ENGINEER'S DAILY REPORT

04-SF-80-13.2/13.9
Contract No. 04-0120F4
{SAS Superstructure}

1. **Guidelines given to T.Y. Lin and PB for CCO recommendations.**
2. **MEP CCO Meeting Agenda.**
3. **PB 3-D Model meeting work sheets and memo with questions.**
4. **Email / Recommendation for lighting in bridge cells below 9.0 M.**

Notes to PB submittal for CCO 42, dated 8/31/07

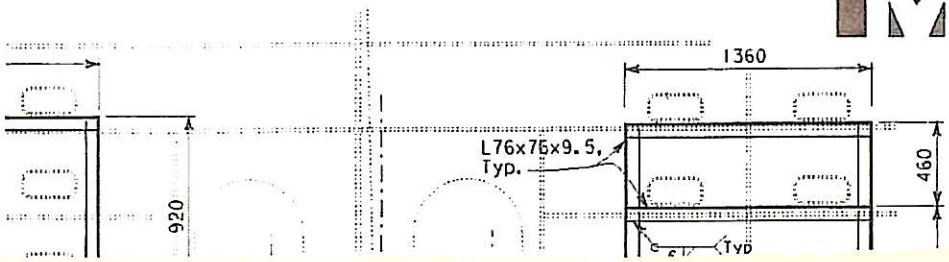
1- The revision Block/legend on every sheet is marked with SHEET XX OF XX
These Marks need to be removed by PB (Do NOT assign sheet No.)

2- The 5 sheets S1, S2, S3, 4of S1, 4of S2, 4of S3, 4of S4 are Marked as Revision one 1 and title is bubbled as revision 1
These supplemental sheets should have the Mark 0: PB to correct

3- File Name (Electronic) is mixed of small and capital letter R: r01, R01, PB to use only R01 (capital letter R).

ATTACHMENT #3 (4/6)

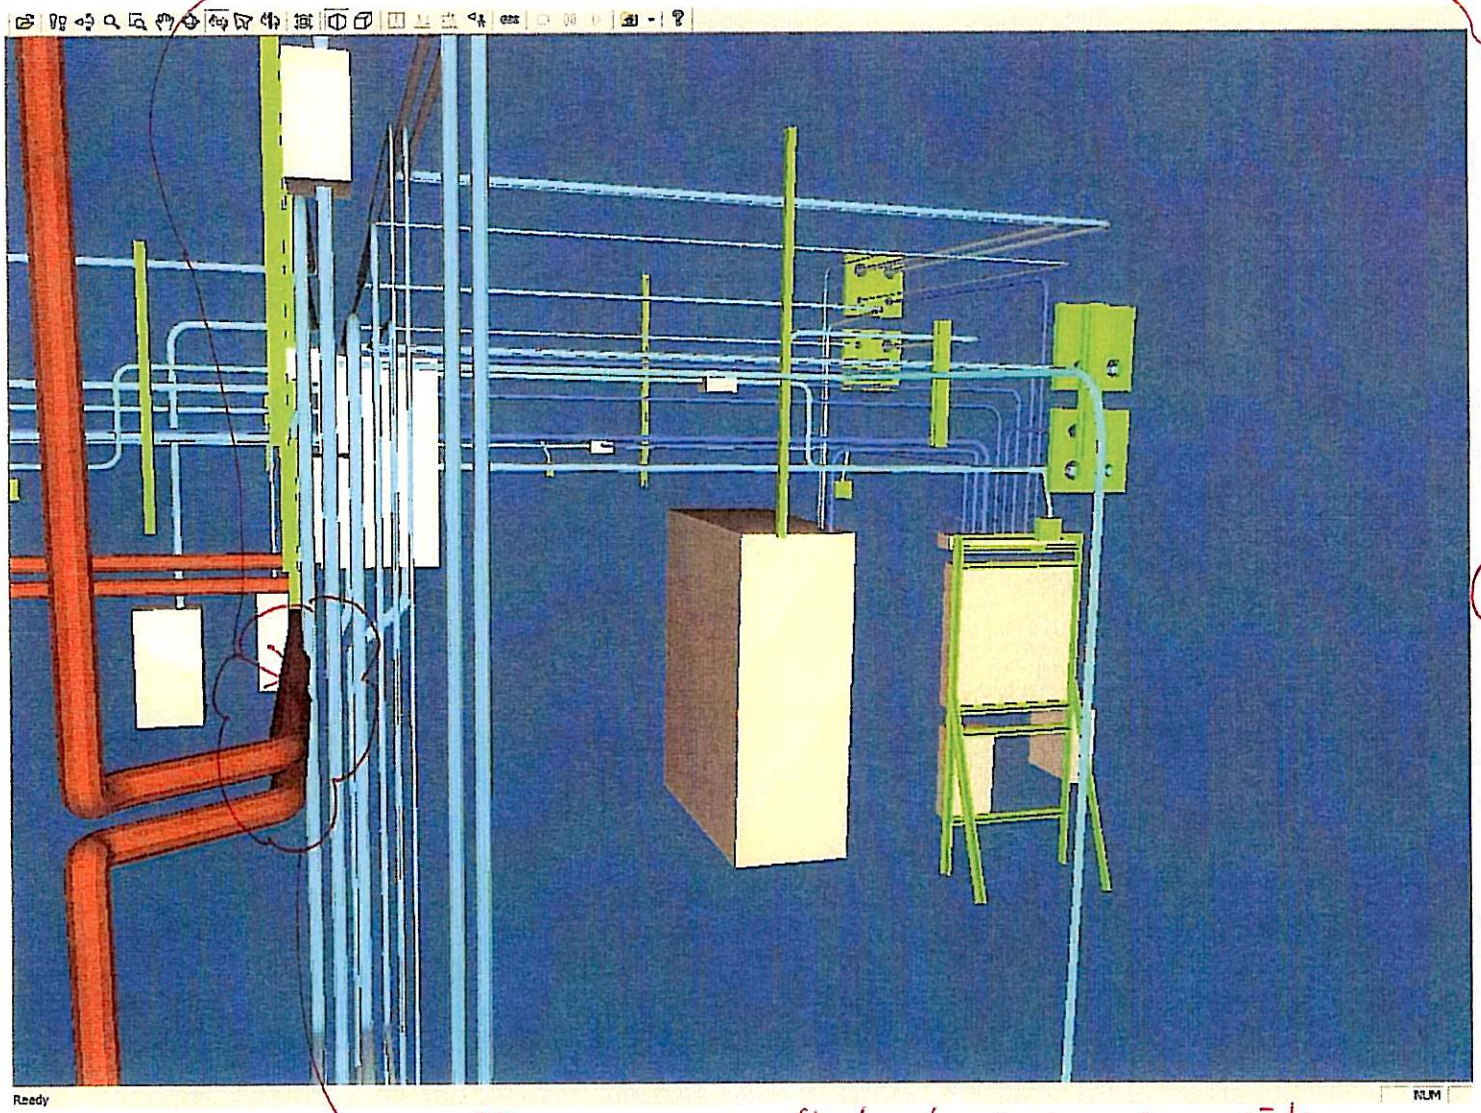
(2) Provide struts to support Mech pipes also

(1) Mech pipes conflict w/ Electrical conduits. Pls revise. Push out Elec conduits further away from tower skin wall as necessary.

ATTACHMENT #3 (6/6)

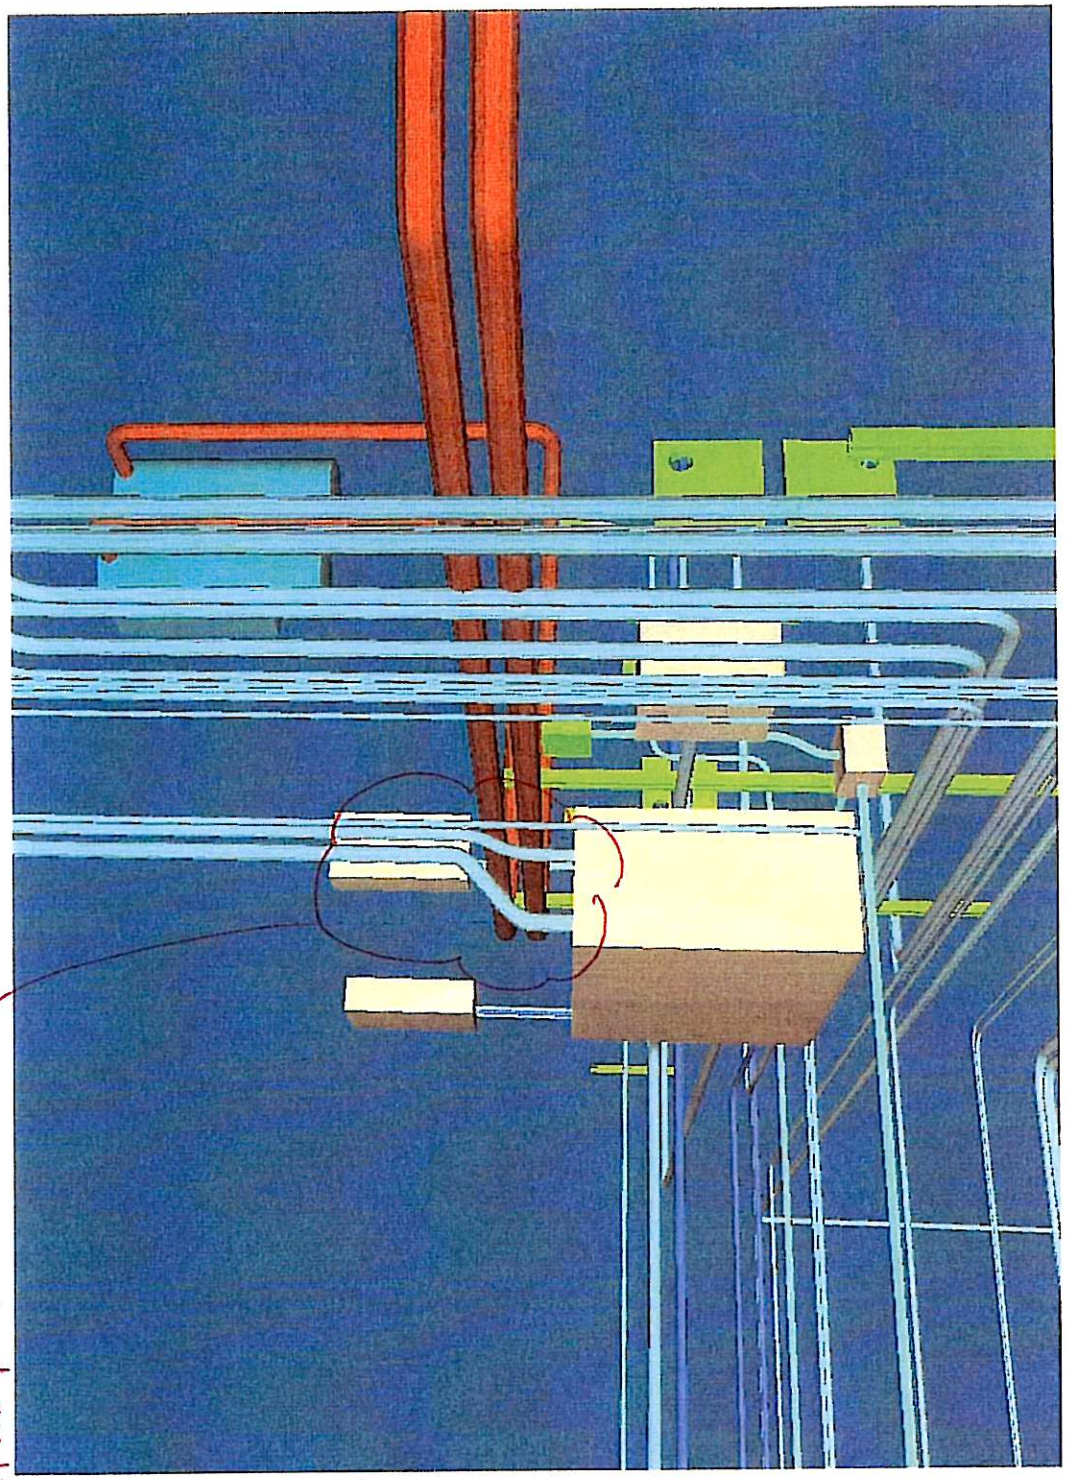
Do not bend conduits going into PB. ~~[illegible]~~ Run straight vert conduits. Other conduits have to be pushed out farther from the wall as a result of this.

DETAILS
TOWER AND SUSPENSION CABLE
TOWER POWER AND LIGHTING

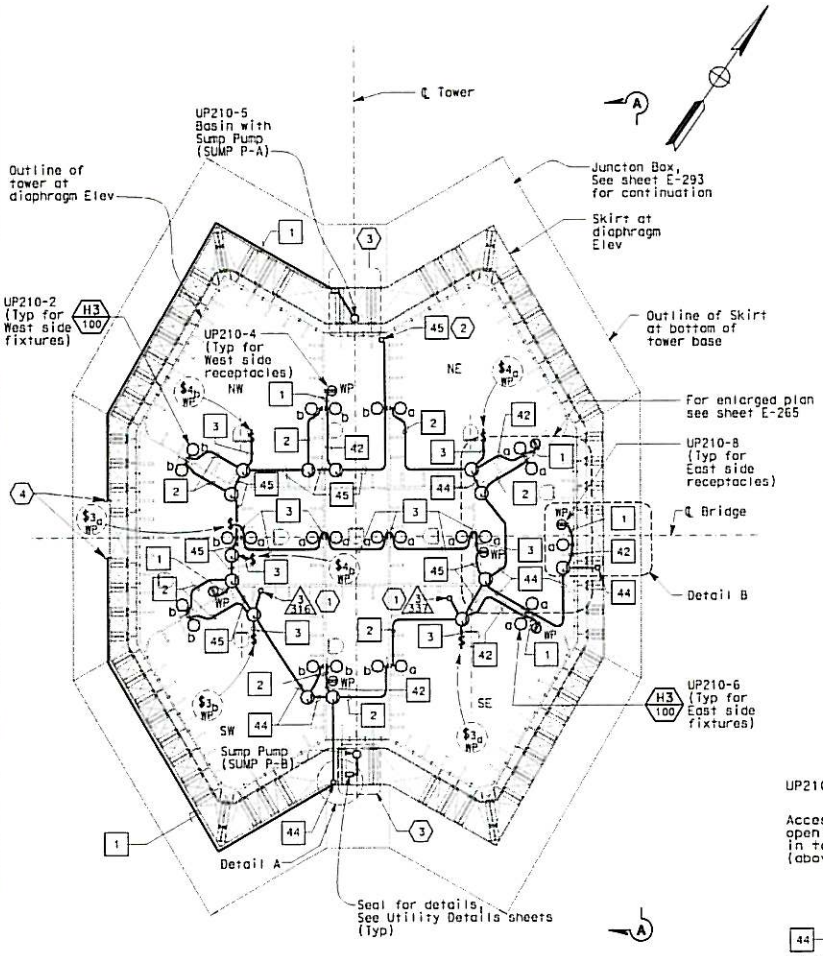
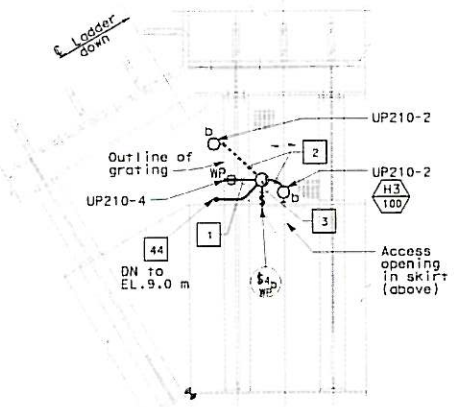
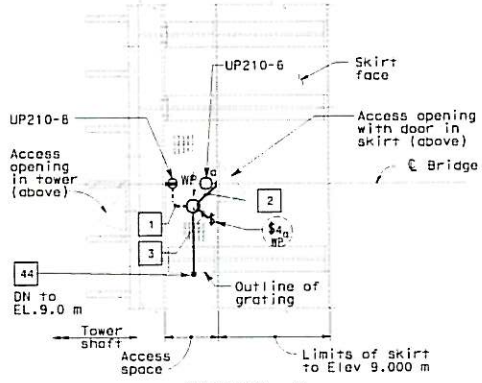
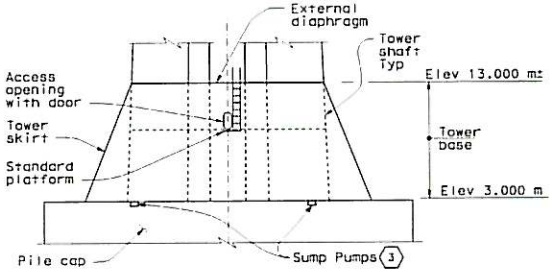
- The eleven cells within the tower structure have access ladders ascending to the top of the pile cap.
- The eleven cells do not have any general lighting installed in the contract plans.

- For the safety of the personnel entering and performing maintenance within these cells I would recommend that these cells have general lighting installed in the contract.
- There are four cells that have either junction boxes or strong motion sensor boxes installed. General light in these cells by the ascending ladder and possible additional lights in the cell if needed.
- This issue was brought up to the district maintenance personnel and they indicated that lighting should be installed to provide a safe working area.
